To:	Julie Mitchell	From:	Drainage (Cecily Austin)
------------	----------------	--------------	--------------------------

Planning App Ref:	PL/2026/04685
Service Ref:	Drainage
Date:	11/09/2026

Full planning permission. Erection of: (i) 1 No. retail convenience store (Class E), 3 No. flexible retail units (Class E), and roadside drive through unit (sui generis); (ii) a 64-bed care home (Class C2); and (iii) 249 No. residential dwellings (Class C3) with associated access, green and blue infrastructure works.

Hawke Ridge Business Park, Westbury, BS13 4LD

Figure 1: Snip from Drainage and Engineering Layout Sheet 11 showing location of potential collapsed culvert

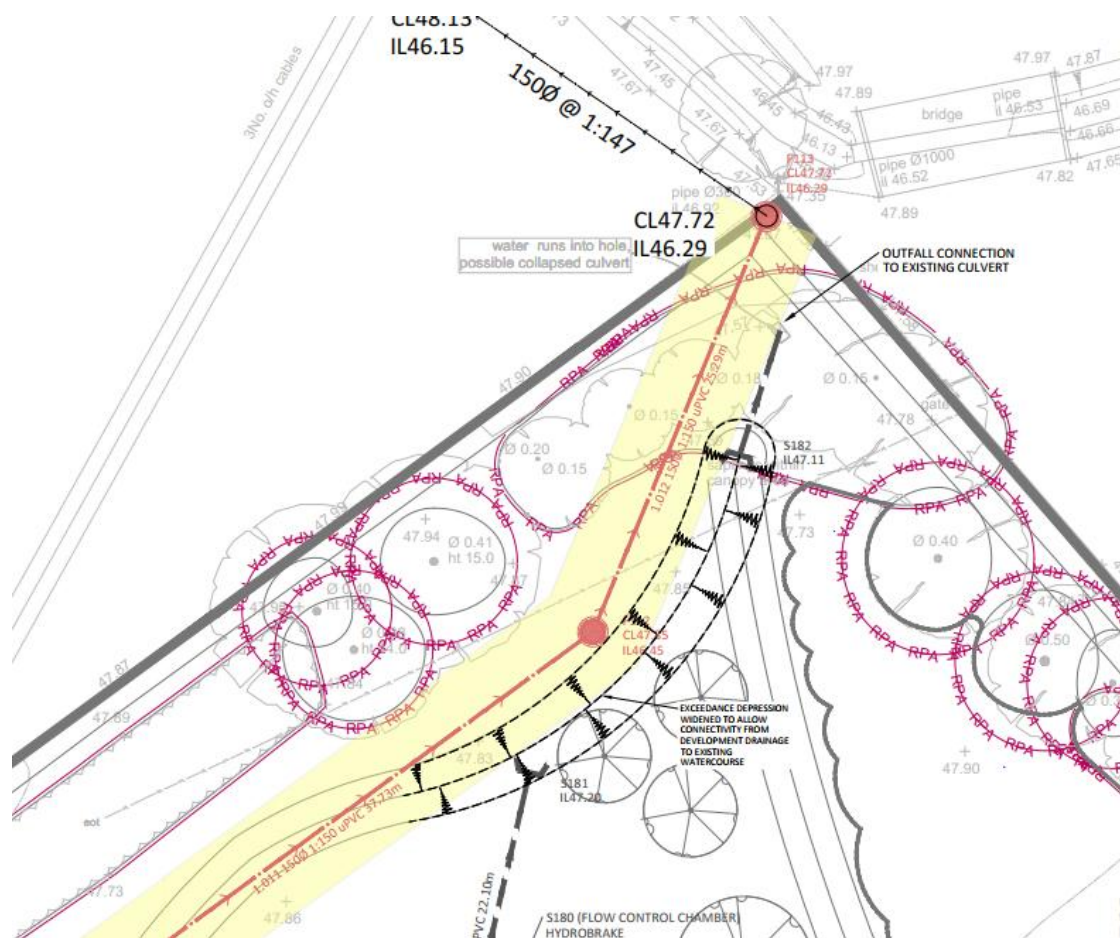
A final point relates to the proposed outfall from Pond 3, which is shown to discharge into an existing culvert. However, the topographical survey indicates that this culvert may be partially collapsed (refer to figure 3 below), and this issue has not been addressed within the submitted documentation.

Furthermore, no information has been provided regarding the current condition, hydraulic function and capacity of this feature. In the absence of this information, it is not possible to determine whether this is an appropriate discharge location.

Consequently, the LLFA cannot support the proposed outfall location at this stage. Further investigation and supporting information are required to demonstrate that the culvert is in suitable condition, functions as intended and can safely receive flows from the proposed development without increasing flood risk.

- The proposed outfall location of pond 3 is not acceptable at this stage due to uncertainty regarding the condition and capacity of the receiving culvert
- A CCTV survey or other related assessment of the culvert shall be undertaken to confirm its current condition and demonstrate that it remains functional and free from collapse or significant obstruction. A hydraulic assessment shall also be undertaken to demonstrate that the culvert can safely accommodate the proposed discharge without increasing flood risk on-site or elsewhere.

- If the culvert is found to be unsuitable, an alternative outfall or a scheme of improvement works should be provided
